Planning application for non-material change to reservoir southern embankment

Application reference: APP/23/00979

Appendix A

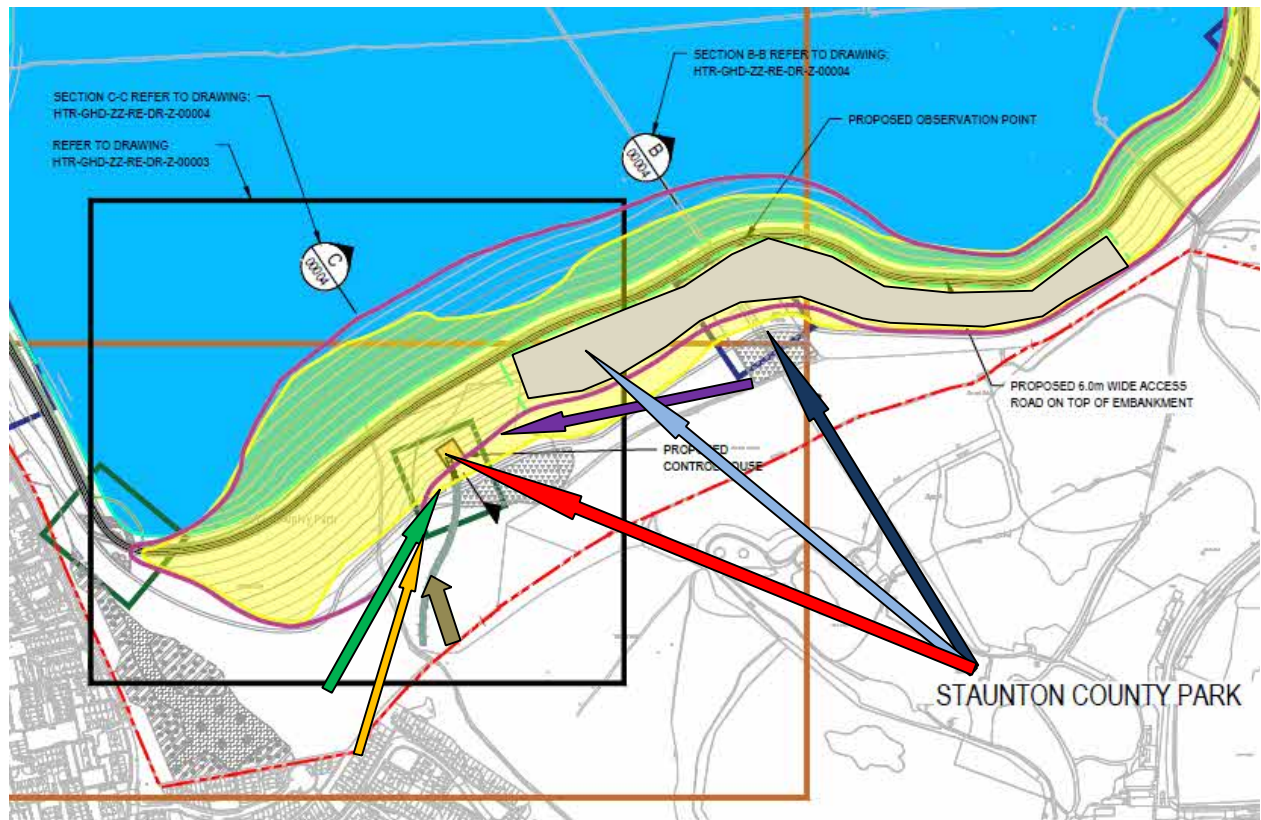
Appendix A shows the vantage points from which views could change as a result of the proposed alterations to the embankment and control house locations. The arrows indicate the views that I believe need to be reassessed. These include where views associated with the historic environment need to be reassessed, further information on this is provided in item 2 below.

Views that need to be re-assessed in order to determine the significance of the proposed changes to the embankment before determining if this is a non-material change in terms of;

Significant visual effect (is the embankment crest or control house more visible from key vantage points as a result of the proposed changes?), or
Impact on the historic environment and setting of the Grade II Listed Historic Park & Gardens and the designated conservation area (is the embankment crest or control house more visible from the SCP Terrace or other vantage points within the areas with historic designations than it would have been under the original proposal?)

Memory Park (from higher ground at Gammon Hill)

Well Meadow (from higher dwellings with windows overlooking the reservoir site)

SCP Terrace towards viewpoint and crest road at the top of the proposed staircase

SCP Terrace to crest road where the embankment has moved the most to the north
(half way between Control House & The Avenue)

SCP Terrace to Control House building and SW embankment crest

Gate view from west side of the remnant of The Avenue woodland peninsula

SCP parkland view as a walker emerges through the gate (incorporating view across to the closer SW toe and new position of the Control House)

Note 1: Having the embankment closer to the woodland helped to screen the embankment and infrastructure when viewed from these key viewpoints, enabling it to blend into the landscape, while being far enough away (minimum 25m) that the construction would not impact the ancient woodland.

Note 2: Section of the southern embankment which was not in outline and was supposed to be fixed at the time of the original planning application shown as grey polygon. Fixing the embankment here was considered necessary to control the impact on the designated historic sites.
